Two Rivers Trail Phase 2 Final Environmental Impact Report

Letter #3: American River Flood Control District (David Aladjem)

Re: Two Rivers Trail (Phase II) Draft Environmental Impact Report

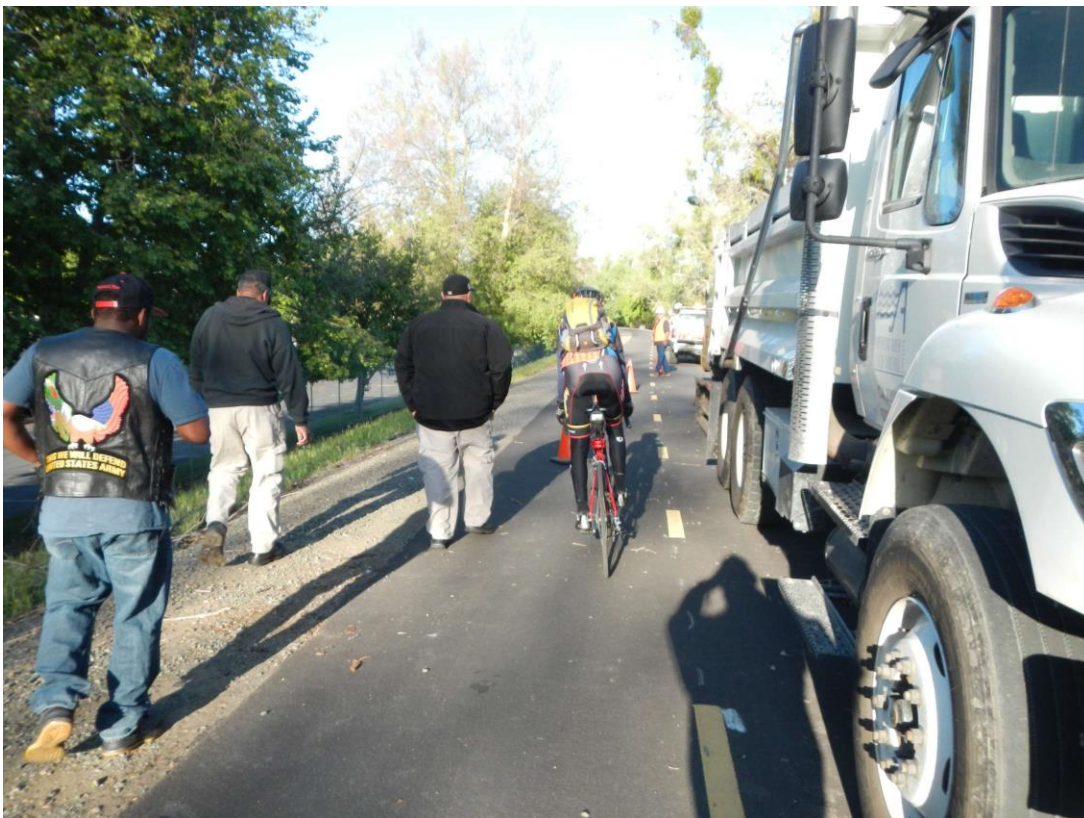
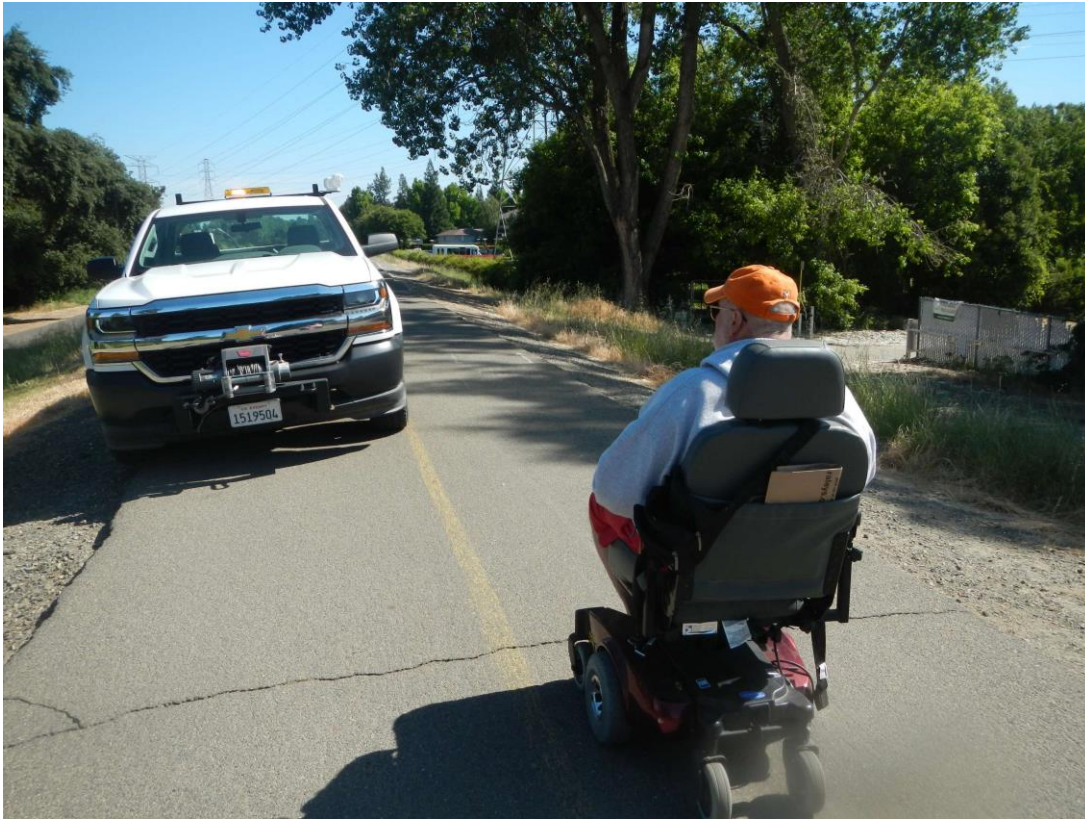
A number of photographs are attached to this letter. Each photograph demonstrates heavy machinery at use on a local levee where the levee crown is also in use by the public. These photographs drive home the importance of avoiding the placement of trail alignments along the crown of a levee. The danger created by the close proximity of bicyclists and pedestrians to operating heavy machinery is

acute, and the margin of safety for the general public using the levee crown is minimal. It is unacceptable to unnecessarily expose the public to such danger.

The commenter's support for the proposed project is noted.
